12V-099

Ref. No.: GR12-041

**Re: Part 573 Noncompliance Information Report:
Rear Center Seat Automatic Locking Retractor (ALR) on certain 2009-2012 model year Subaru
Forester Vehicles (Third Submission)**

<Affected Center Seat Belts of Rear Seat>

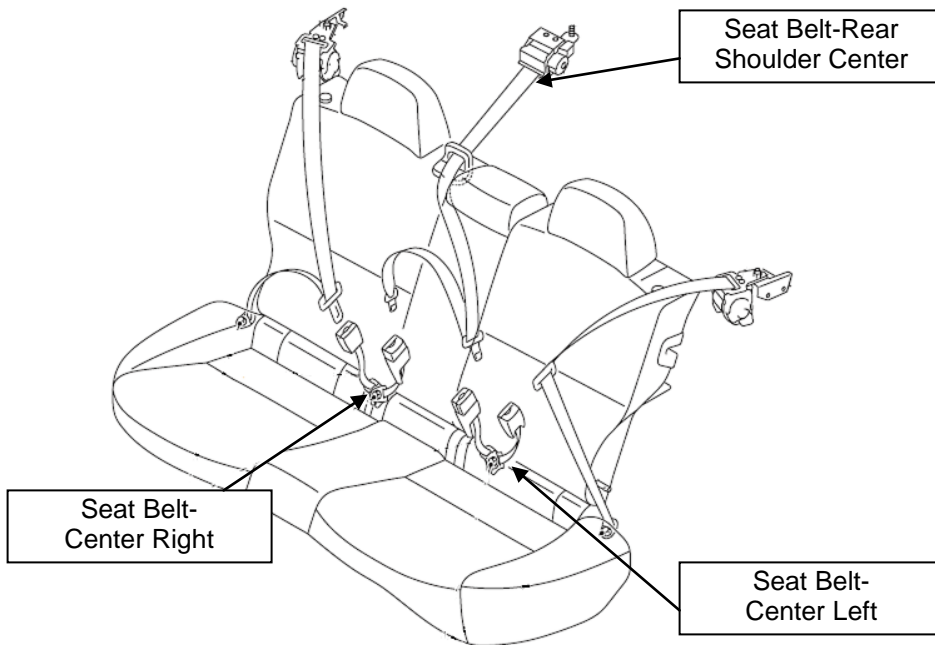
Subaru has determined that the seatbelt assemblies located in the rear center seating position of certain 2009 through 2012 model year Forester vehicles do not meet the lockability requirements prescribed under S7.1.1.5(a) and S7.1.1.5(c) of FMVSS No. 208, "Occupant Crash Protection." Specifically, depending on the shape and size of the CRS being installed, the ALR might not activate (i.e. lock), which could prevent the CRS from being tightly secured to the vehicle.

This noncompliance determination only applies to the rear center seating position (i.e. the ALRs located at the front passenger and rear outboard seating positions are not affected).

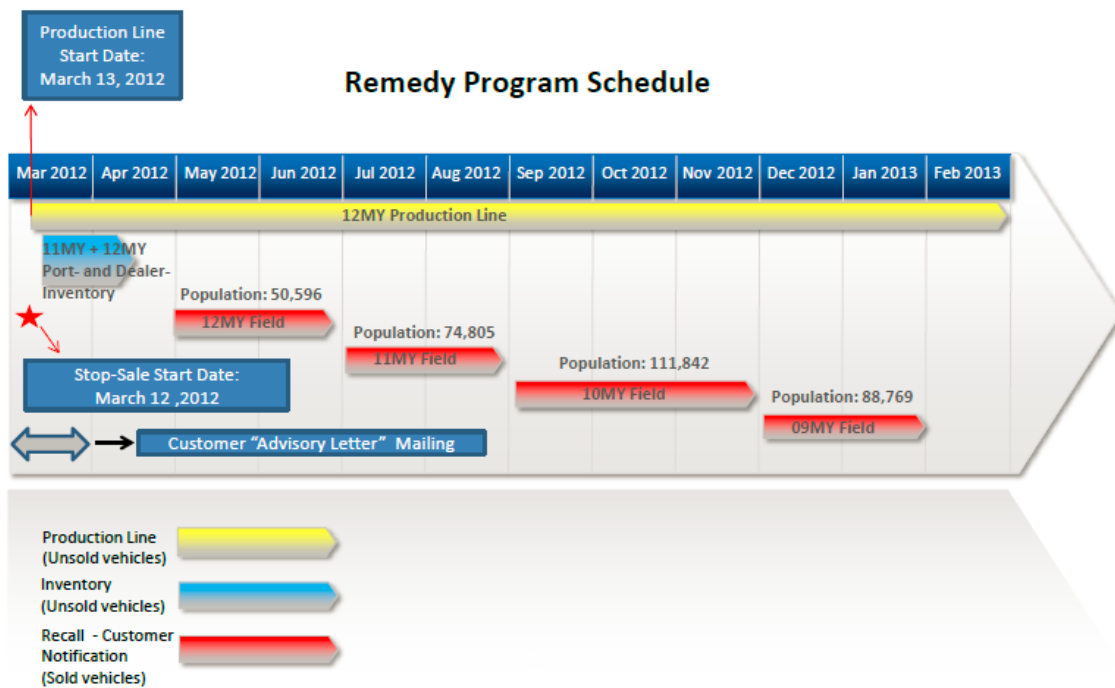
(i)-(ii) Subaru of America, Inc. notified U.S. dealers on March 12, 2012. The remedy plan for unsold vehicles in inventory calls for dealers to replace the rear center seat belt assembly with a new one having a shorter belt length and modified Automatic Locking Retractor (ALR) gears. Starting in September 2012, Subaru will phase-in an alternative plan to remedy previously sold (i.e. NOT production line) vehicles. The alternative plan calls for dealers to replace the rear seat belt buckle assemblies with a new one having a shorter belt length and add a resin sleeve to one of the rear center seat belt buckles.

Due to production constraints of the supplier having to manufacture large quantities of replacement parts for the following: (1) Production line, (2) Port- and dealer- inventory, and (3) Customer vehicles, the remedy will be launched in a phased approach as illustrated in the chart below:
